PRELIMINARY: 16 Newlands Street,
Chevy Chase Historic District

From: Tully, Tania
Sent: Wednesday, January 05, 2005 10:50 AM
To: Ramon Santos (E-mail)
Subject: 16 Newlands - HPC Meeting Transcripts

HISTORIC PRESERVATION COMMISSION STAFF REPORT

Address:	16 Newlands Street	Meeting Date:	12/15/04
Applicant:	Dr. Robert and Susan Morgenstein (Ramon Santos, Agent)	Report Date:	12/07/04
Resource:	Contributing Resource Chevy Chase Village Historic District	Public Notice:	12/1/04
Review:	PRELIMINARY	Tax Credit:	None
		Staff:	Tania Tully
Case Number:	N/A

View from Rear Yard

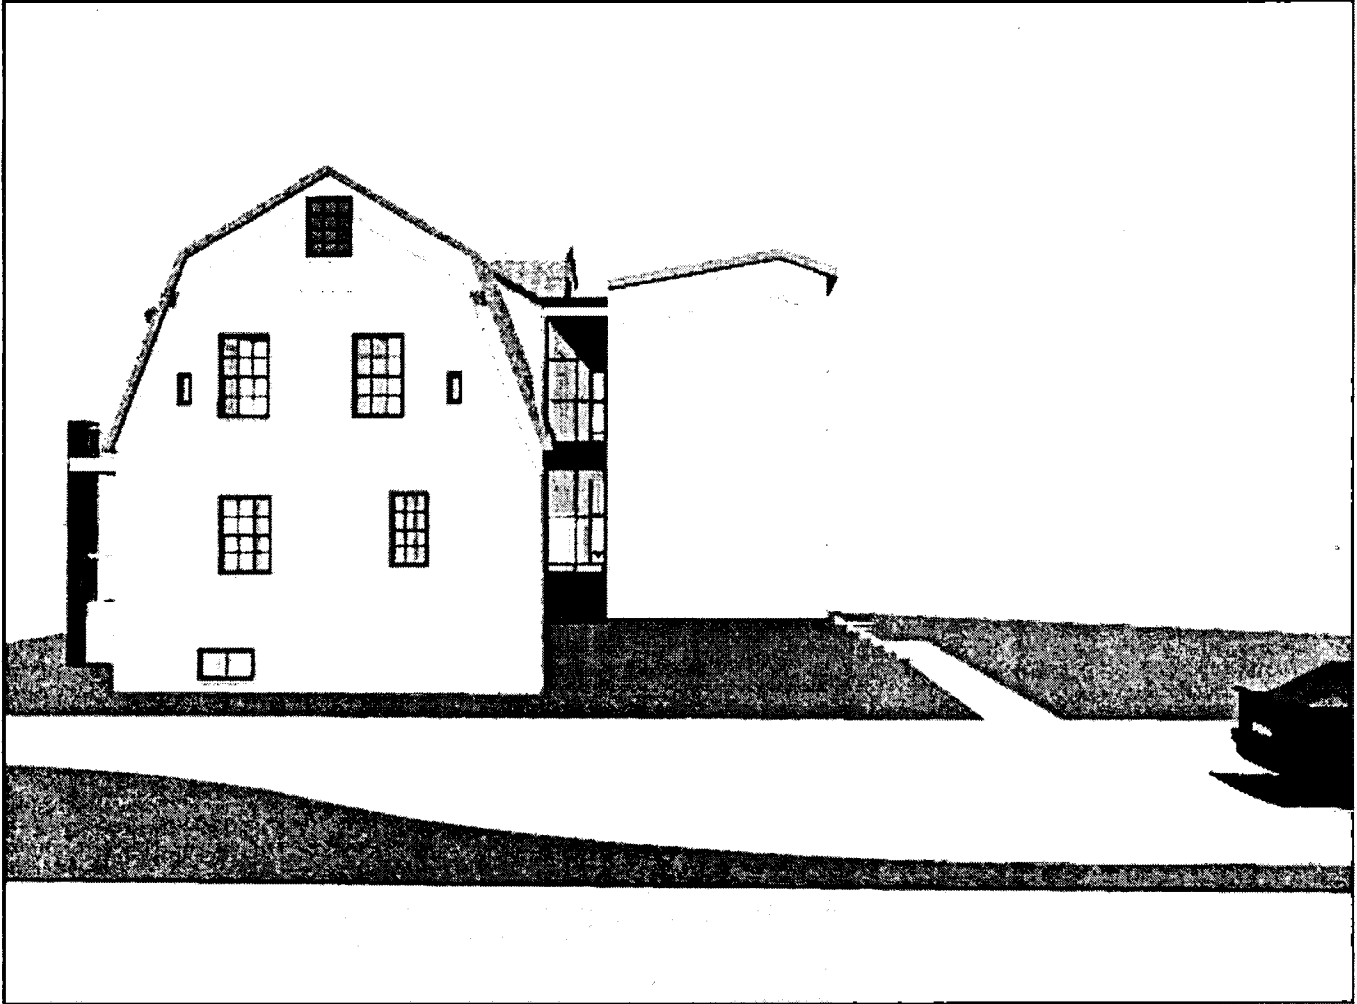
17 When you look at your rear yard, that feels pretty good in
18 terms of the other perspective, and other elevation. The rear side
19 starts to look fine, but when you look, what you're saying, your view
20 from the driveway just feels very weak to me. I think it's, whether
21 the roof wants to be flat or maybe it's simply sloped in a single
22 direction, and somehow brought down just ever so slightly to keep it in
23 that elevation, it just hurts. And coming around the other side, it
24 looks better.

14 MS. PROTHRO-WILLIAMS: But like for instance on your, on
15 this view of your yard, can we get that up, Tania, if on the stucco,
16 yes, the stucco side, maybe if you just like cut an L out of the corner
17 or something, so it's not a full box.

1 about that. I'm about on the stucco section, to relieve the boxy
2 quality that Julia was referring to. You could, you could take some
3 kind of a, you know, a corner out of there and do like an angle, an L,
4 I mean just take it -- I'm not talking about anything substantial, but
5 just rather than having it come to a 90-degree angle, just cut it out
6 and do like almost like a --

View from Driveway

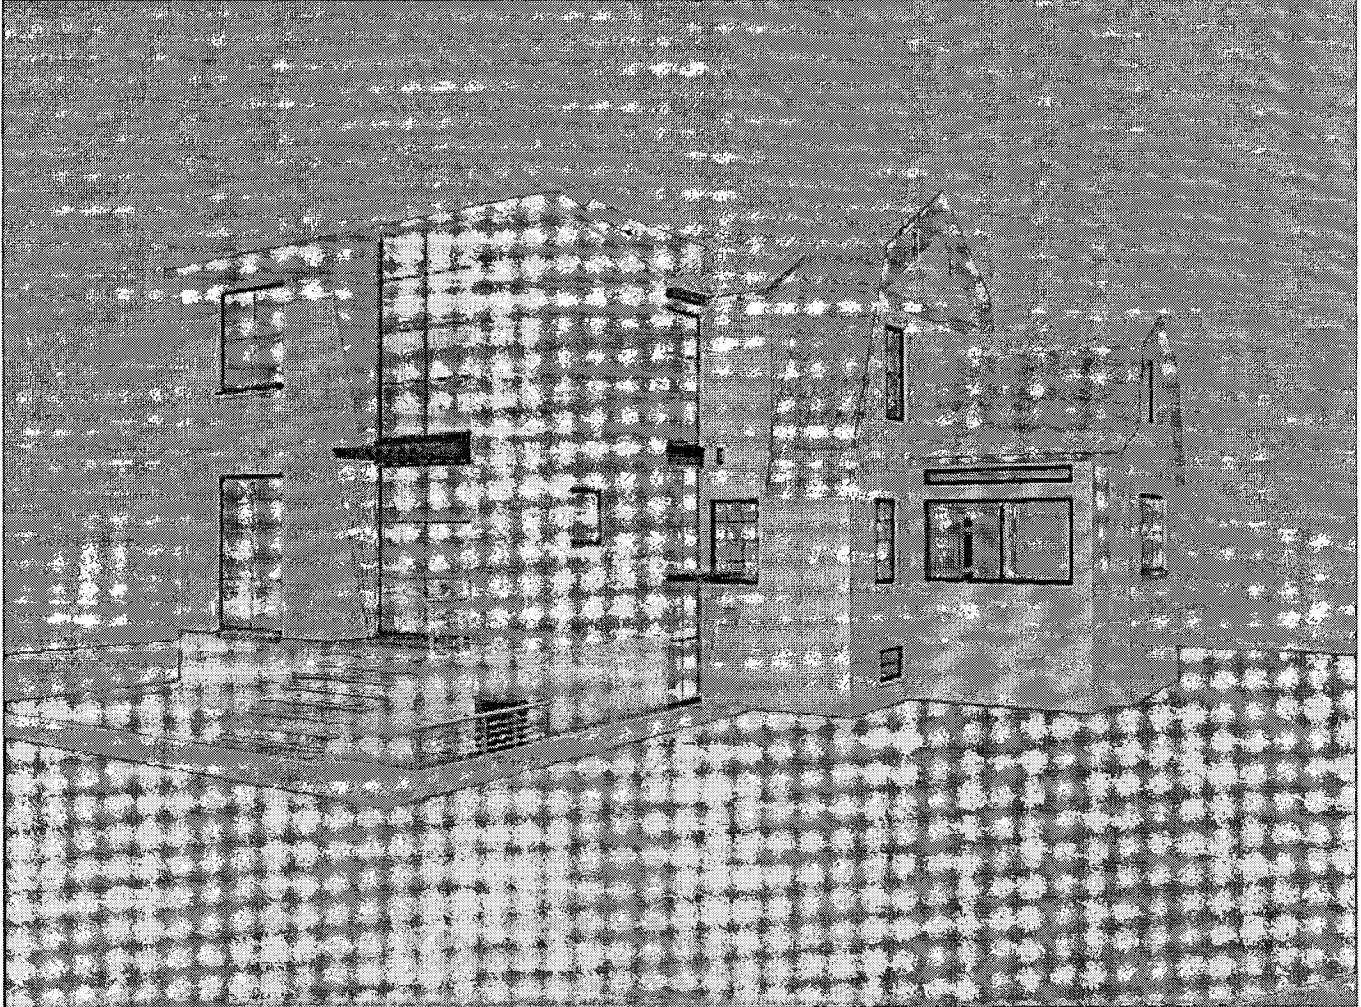
9 MR. FULLER: One thing that I guess I haven't paid
10 attention to, I was looking at the view from the driveway. The view
11 from the driveway, it read to me as if the new addition is set back
12 from the face of the existing house. But when I look at it in plan,
13 we're almost to the same line. And I think that concerns me a little
14 bit. I think I prefer to see some better separation there.

11 MS. O'MALLEY: We need a view straight on from that side,
12 like the view from the driveway is a straight on. But the -- we don't
13 have a rear, we don't have a view from the other side. We only have an
14 angled view from the back.

8 MS. WATKINS: And your view from the driveway, your really
9 haven't shown the stairs, the back stairs, and the stairs with the
10 railing, the detail around the -- is there a stair to the basement
11 there, it appears?

13 MR. SANTOS: Yes, and the view from the driveway, the
14 perspective actually is cutting off the stair, the rear stair.

15 MS. WATKINS: I think when you come back, we really need
16 some elevations other than perspectives.

15 MR. STEWART: Well, that kind of relates to the way that
16 the kitchen is working, where the kitchen actually goes in and becomes
17 the butler's pantry for the dining room. So the idea is that the
18 counters align. And if you start pulling all that over, we start to
19 compromise the ability to put the range where it is. So there is,
20 there again, it's functional relationships that are prevented for
21 greater articulation than the rest.

Basement

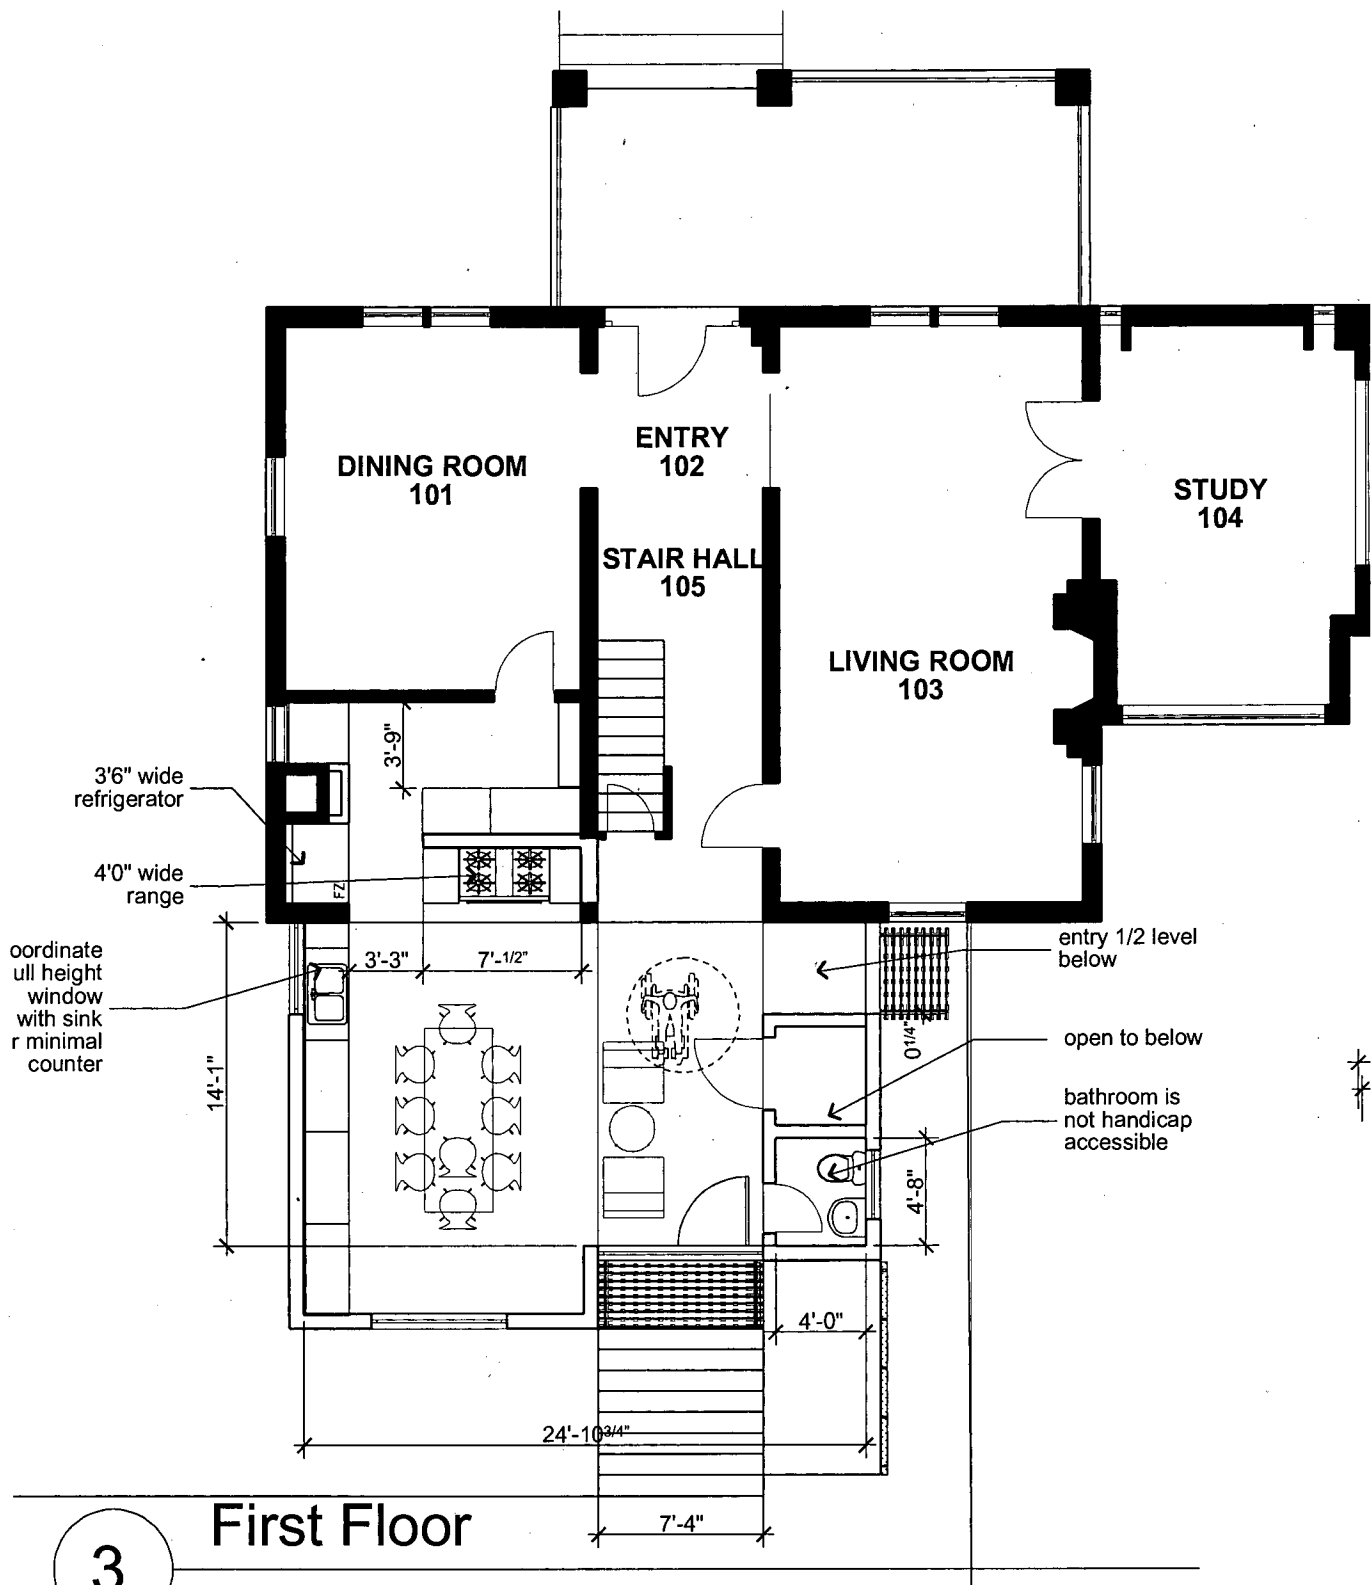
3 MR. BRESLIN: Yes. You have a wheel chair graphic in your
4 plans.

8 MR. BRESLIN: Can you point it out? I can't see it.

9 MR. STEWART: In the basement plan, you don't see it. What
10 you see next to the house is, in that plan it show the -- thank you.
